TECHNICAL SPECIFICATIONS CHANGE REQUEST 171  
SAFETY EVALUATION

Wisconsin Electric Power Company (Licensee) is applying for amendments to Facility Operating Licenses DPR-24 and DPR-27 for Point Beach Nuclear Plant, Units 1 and 2. The proposed changes extend the operation of both units with the current heatup and cooldown limit curves in the Technical Specifications to 23.6 effective full power years (EFPY). The Basis section for Specification 15.3.1.B, "Pressure/Temperature Limits," is also being revised to reflect the methodology for curve compilation.

Figure 15.3.1-1/PBNP Units 1 & 2  
 Heatup Limitations Applicable to  
 18.1-23.6 Effective Full Power Years  
 (Approximately January 1995-2001)

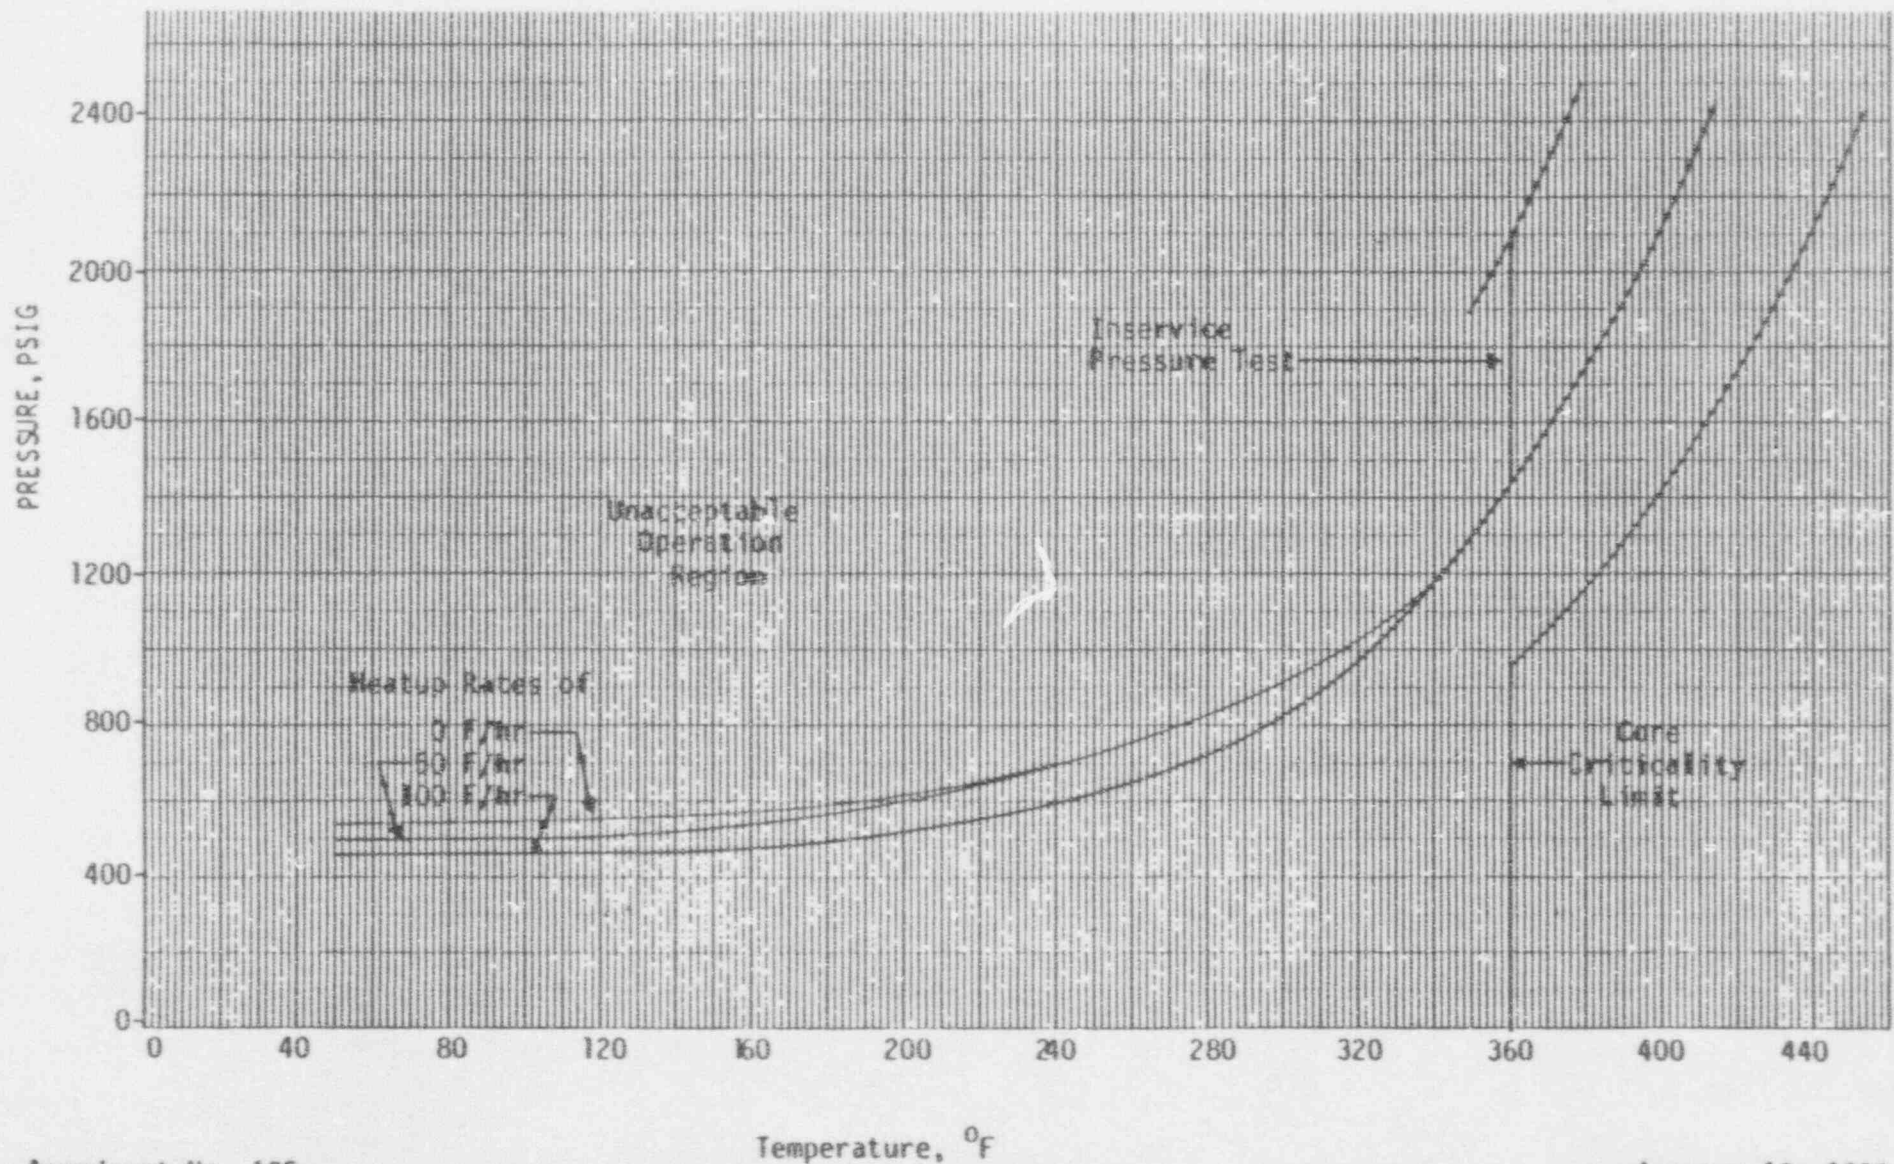
Technical Specifications Figures 15.3.1-1, "Heatup Limitations," and 15.3.1-2, "Cooldown Limitations," are revised to reflect their applicability through 23.6 effective full power years (EFPY), or approximately January 1, 2001. Exposure of reactor vessel materials to neutron radiation throughout operating life results in a change in the reference temperature ( $RT_{NDT}$ ) of the materials due to neutron embrittlement. This change in reference temperature is calculated periodically and appropriate limits revised. Because of flux reduction measures that we have implemented, the rate of neutron embrittlement of the Point Beach reactor vessels has been reduced significantly over what was projected when the heatup and cooldown curves were previously submitted on October 3, 1989. Therefore, the heatup and cooldown limitation curves being submitted remain unchanged from the curves presently contained in the Technical Specifications.

The proposed heatup and cooldown curves are identical to the current heatup and cooldown curves except for their projected expiration dates. The curves were calculated using the most limiting weld and fluence information from either unit as input to the acceptable methodology of Regulatory Guide 1.99, Revision 2.
